**Environmental
Planning
Commission**

**Agenda Number: 02
Project Number: 1000936
Case Number: 18EPC-40014
Hearing Date: April 12, 2018**

Staff Report

Agent	Consensus Planning
Applicant	Hotsy Equipment Company
Request	Site Development Plan for Building Permit
Legal Description	Tract 4, Paradise Plaza
Location	East side of Unser Blvd. NW between Crown Rd. NW and Summer Ridge Rd. NW
Size	approximately 2 acres
Existing Zoning	SU-1 for C-1 with auto-related uses controlled by project 1000936
Proposed Zoning	N/A

SITE PLAN FOR BUILDING PERMIT

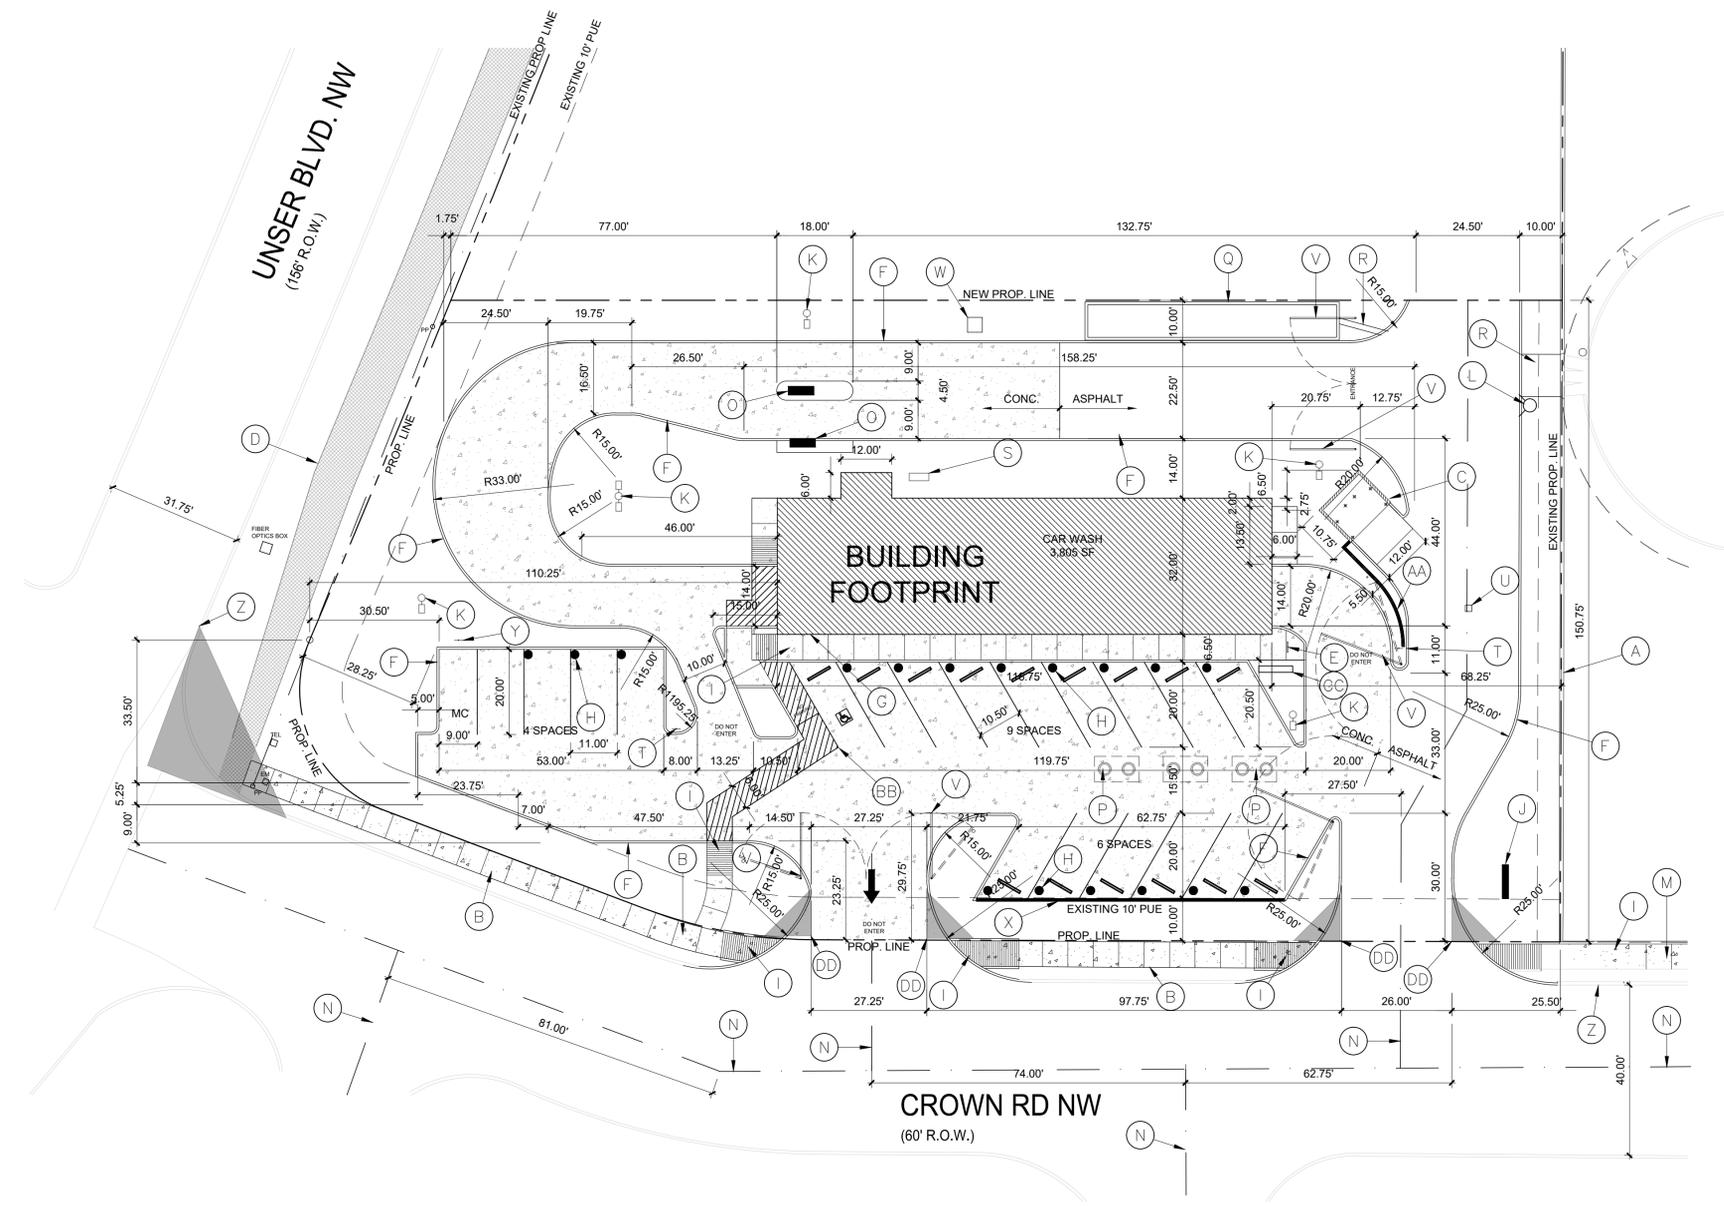
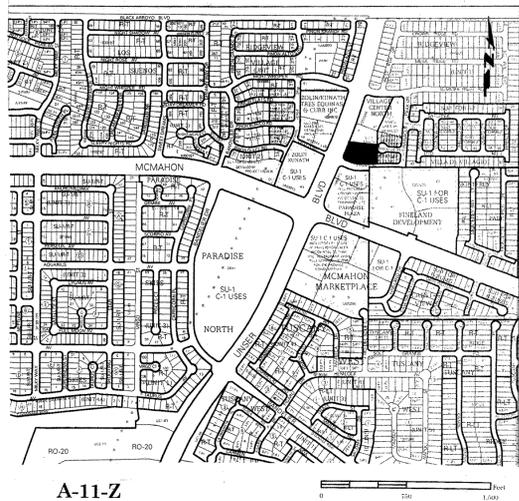
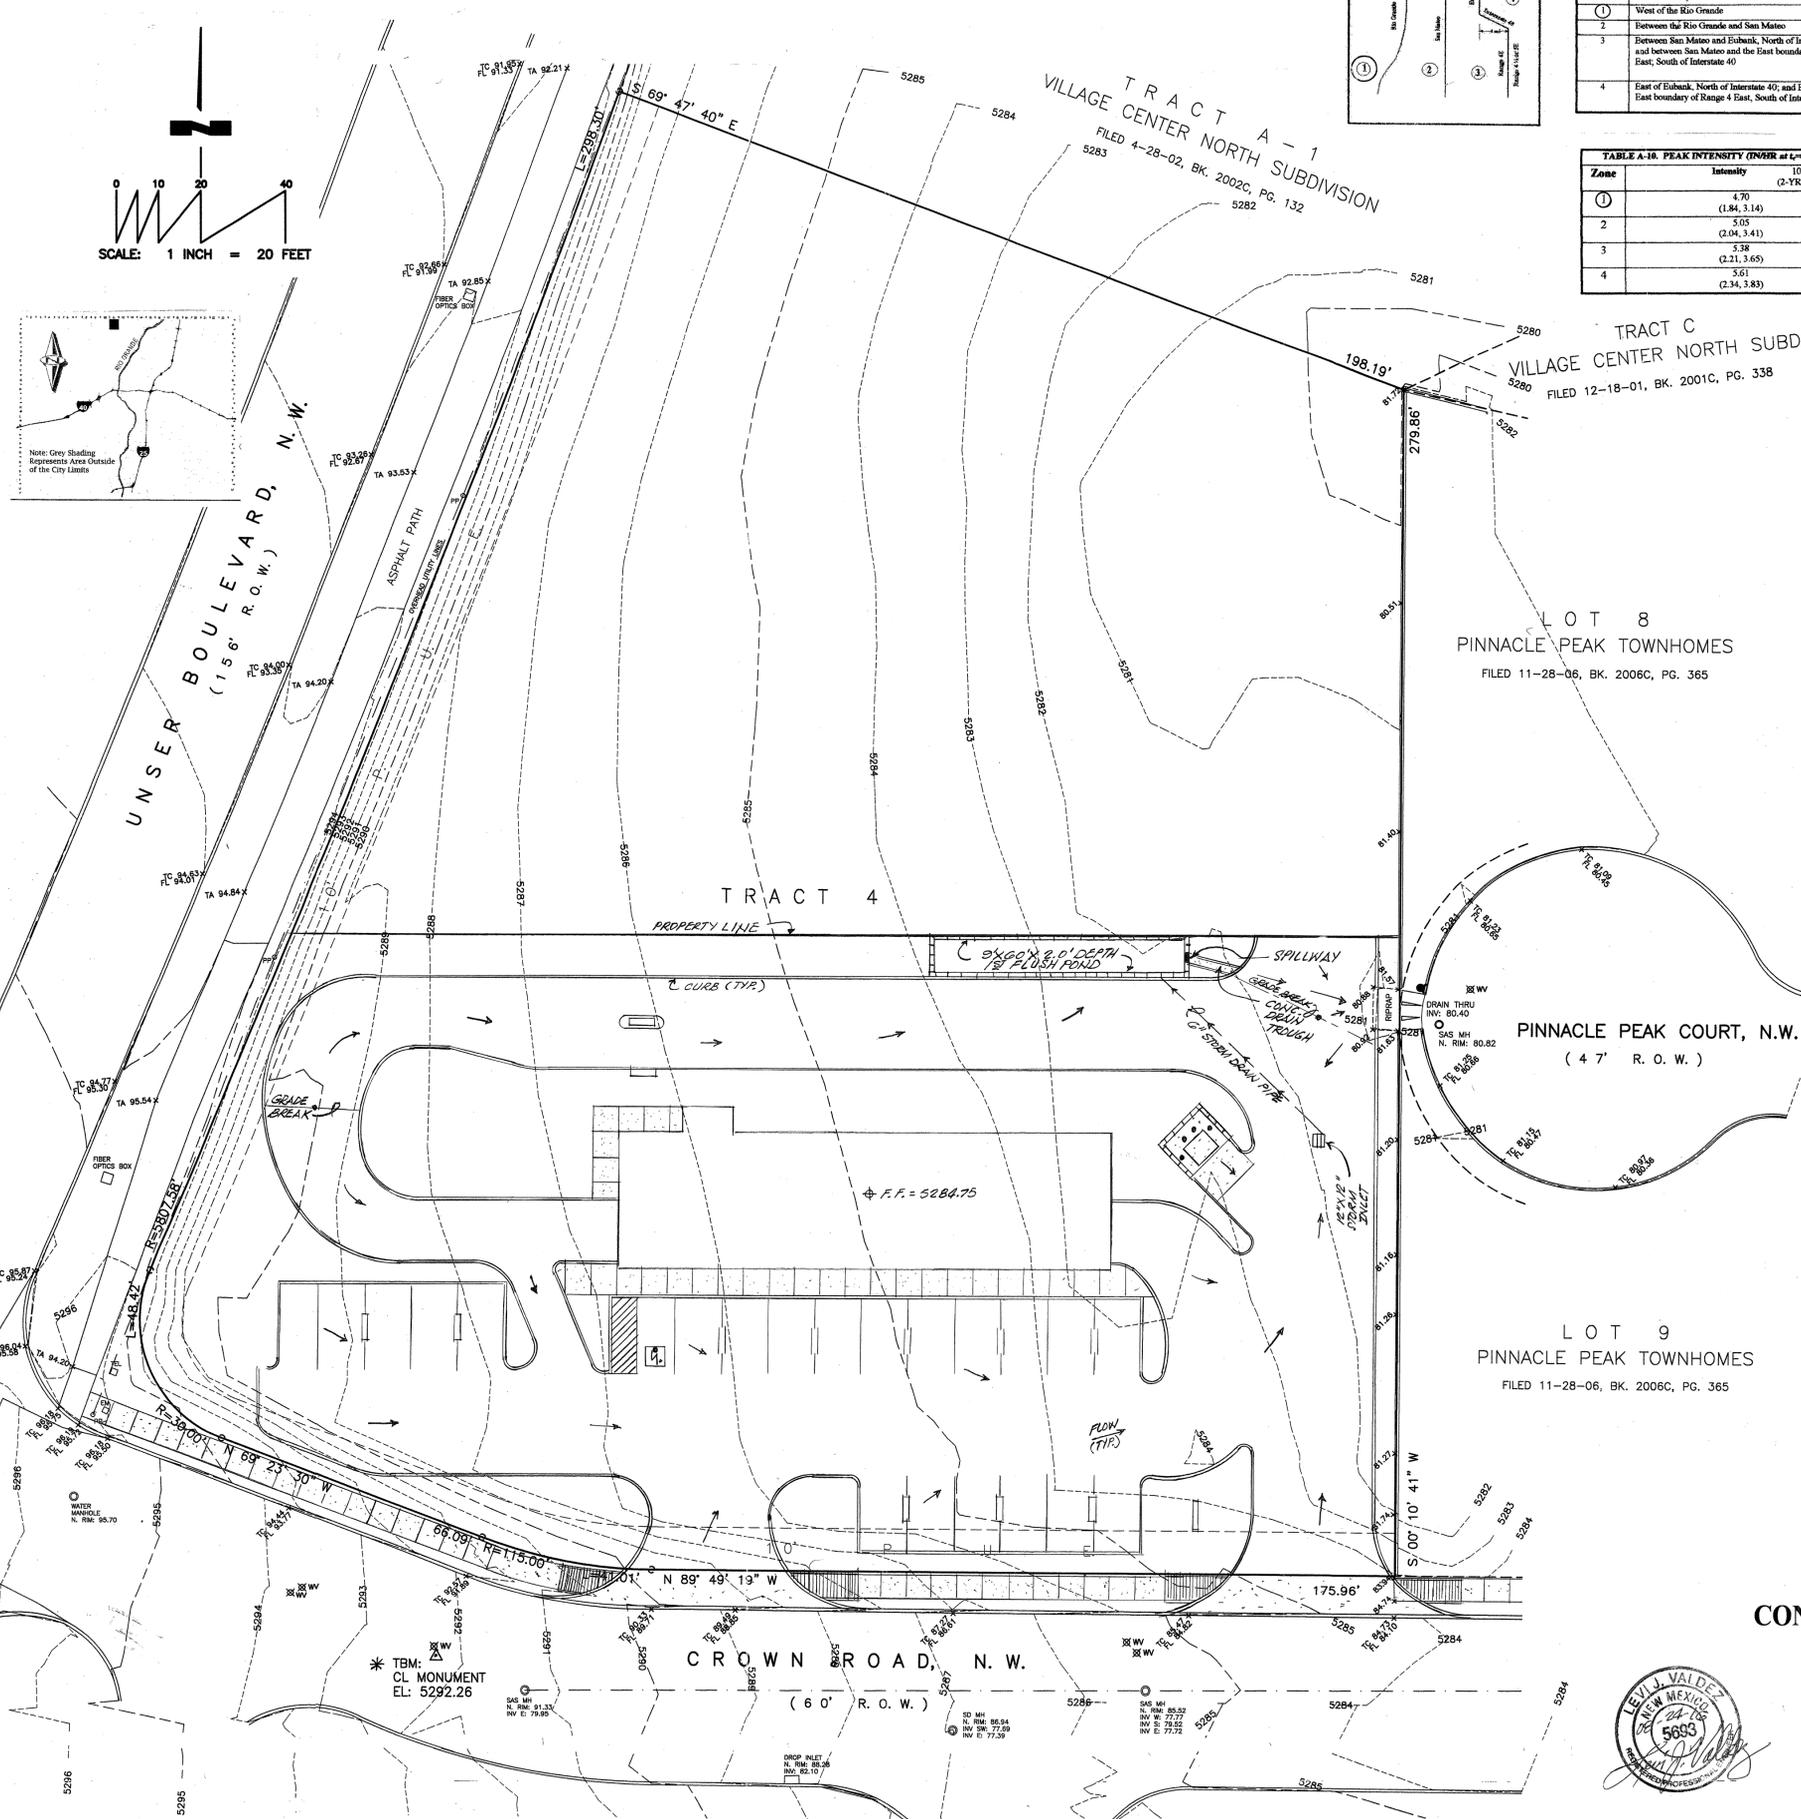
- Vicinity Map on Sheet C2 needs the Zone Atlas page listed.
- Motorcycle parking needs to be dimensioned and call out location of detail in keyed note. Keyed note Y calls out the sign but does not call out detail on Sheet C5.

- Radii of curb along vehicle paths need to be a minimum of 15'. There are some labeled 10' and several not labeled at all.
- The western access point along Crown Road should be listed as exit only along with proper signage of "Do Not Enter" posted and pavement directional arrows. The location of this access should be reassessed as a vehicle in the accessible parking space would be required to back up a considerable distance in order to utilize this exit.
- A new fire hydrant is shown in the middle of the eastern access point along Crown Road. Remove or relocate.

- The new fire hydrant (L) located in the middle of SE entrance will need to be relocated. Storm inlet (U), located in front of new/proposed refuse enclosure (C), will need to be able to withstand 57,000lbs. Will need to re-angle (C) enclosure and/or reduce wall (X), for safe refuse truck access/exit. All noted issues are indicated on Pg. C-2. Complete site plan should include exits/entrances w/dimensions on North side of proposed bldg., to verify safe truck exit from property. All new/proposed refuse enclosures must be built to COA minimum requirements.
